**WRITTEN REPRESENTATION
ON BEHALF OF McDONALD'S RESTAURANTS LIMITED
PROPOSED HIGHWAY WORKS A38, DERBY**

ADL/RG/2680/05D

November 2019

Document: Written Representation
Project: Proposed Highway Works A38, Derby
Client: McDonald's Restaurants Ltd
ADL Reference: 2680

Scale
 1:500 A4
 APPENDIX 4.0

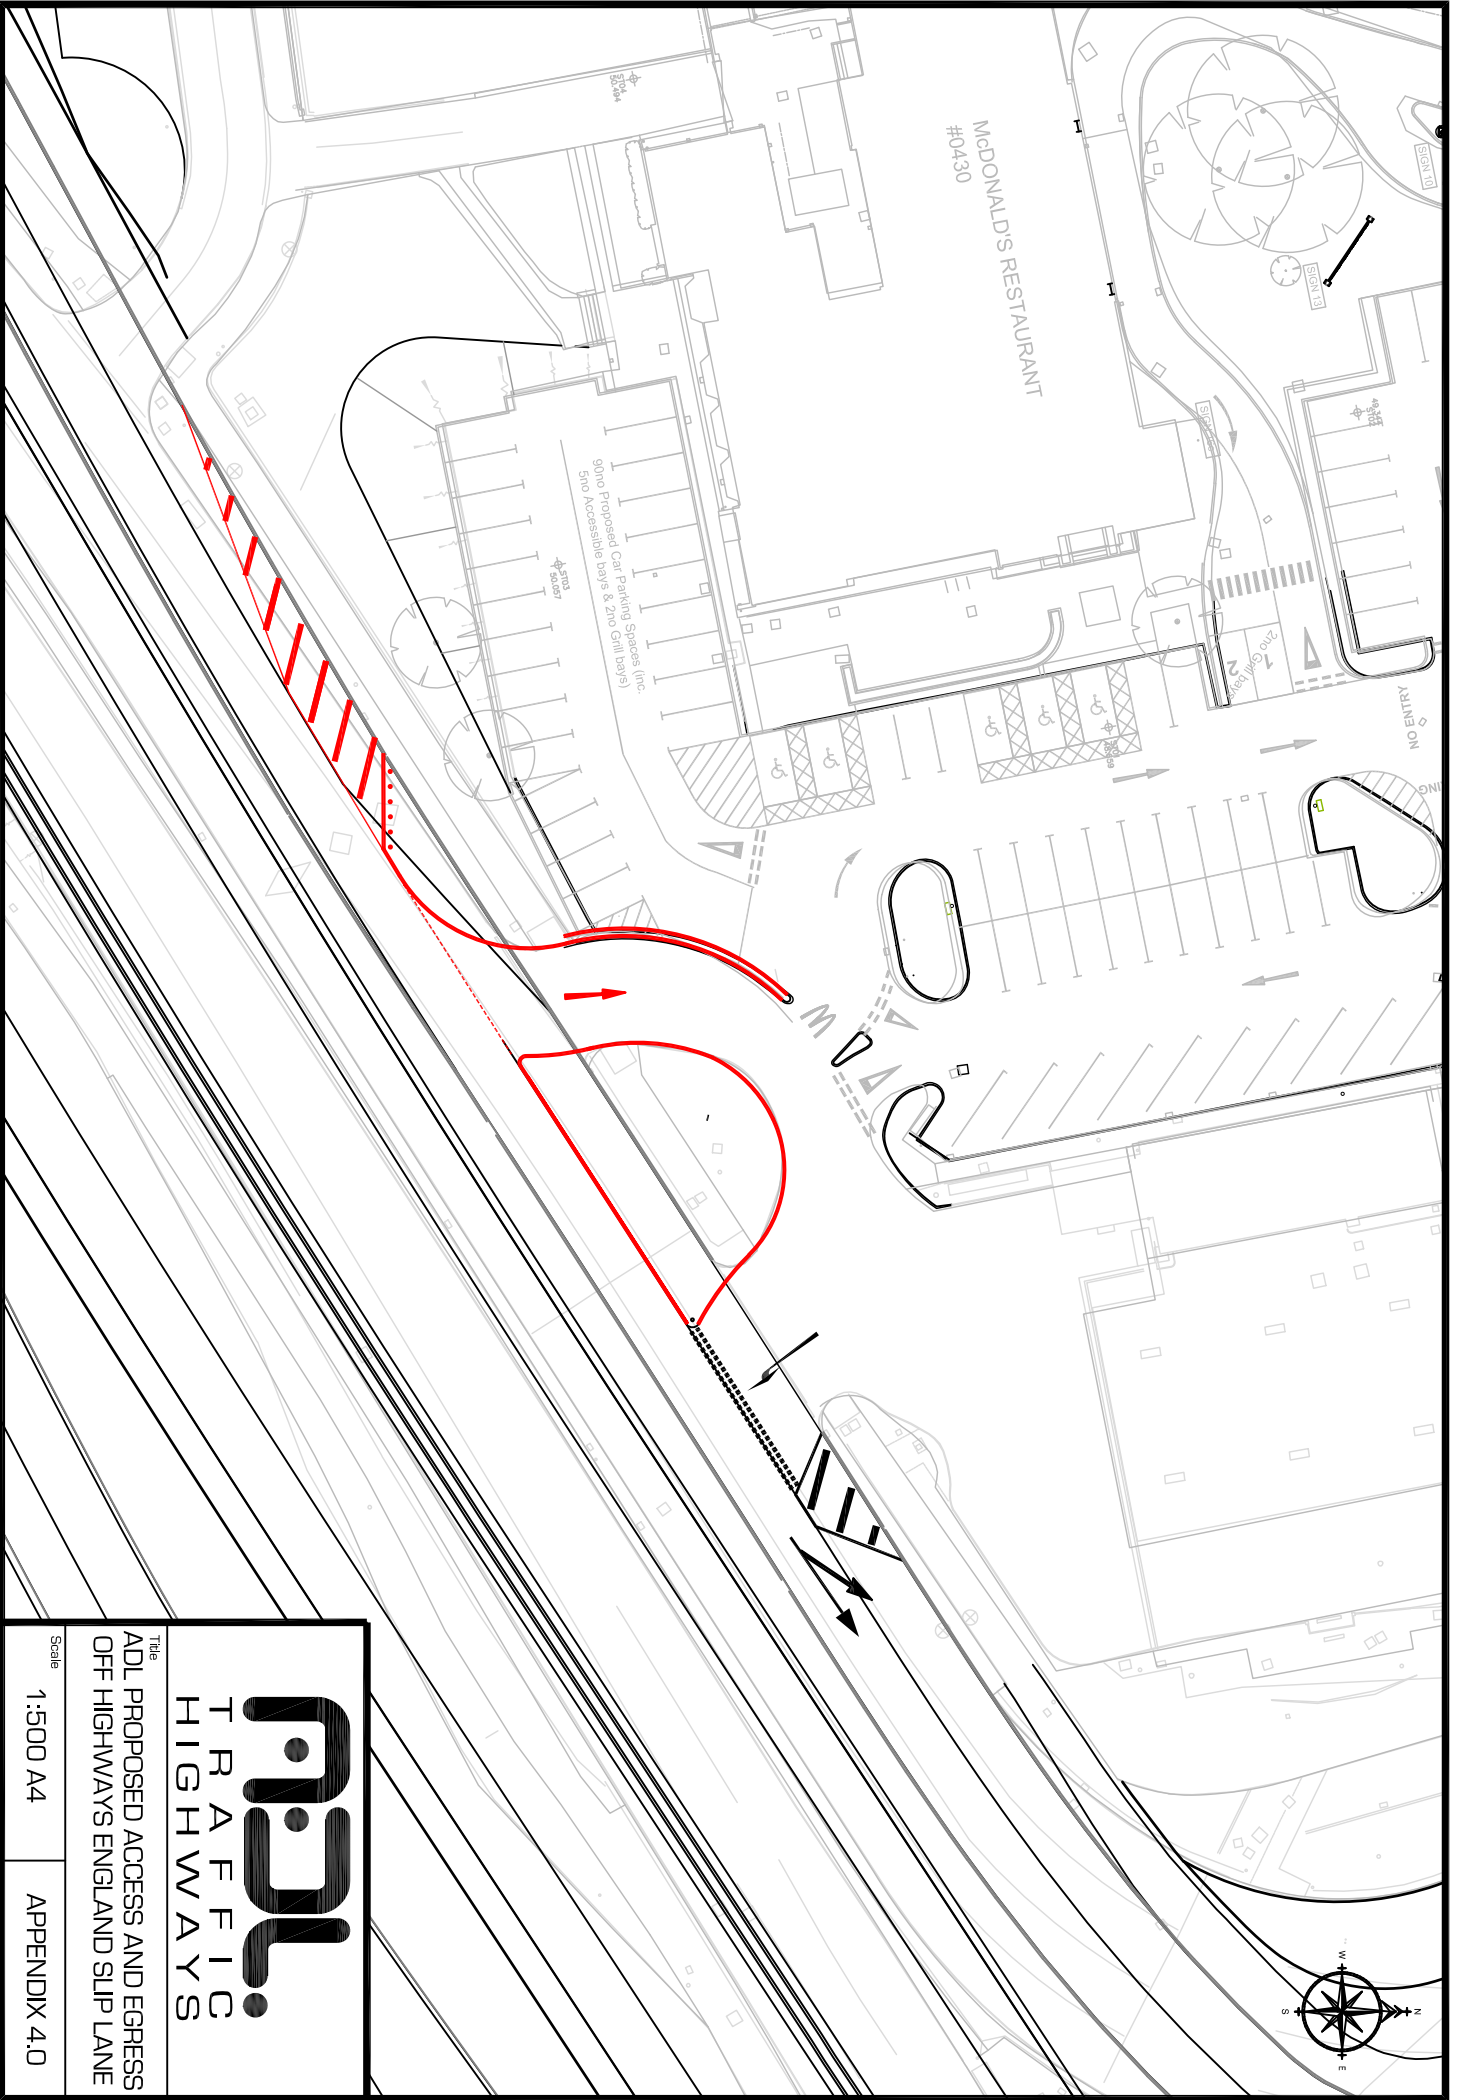
3.1.11 It is the view of McDonald’s and their consultants, that the most current guidance as set out in CD122 does not preclude or prohibit the provision of an access or egress from the slip road, i.e. an access from the A38. As a result, HE should revisit the scheme design in order to retain the existing access and egress from the A38 exit slip road.

3.1.12 A sketch amendment to the proposal drawing is provided at Appendix 4.0 which maintains HE’s layout, however, also re-opens the existing access.

The
 ADL PROPOSED ACCESS AND EGRESS
 OFF HIGHWAYS ENGLAND SLIP LANE
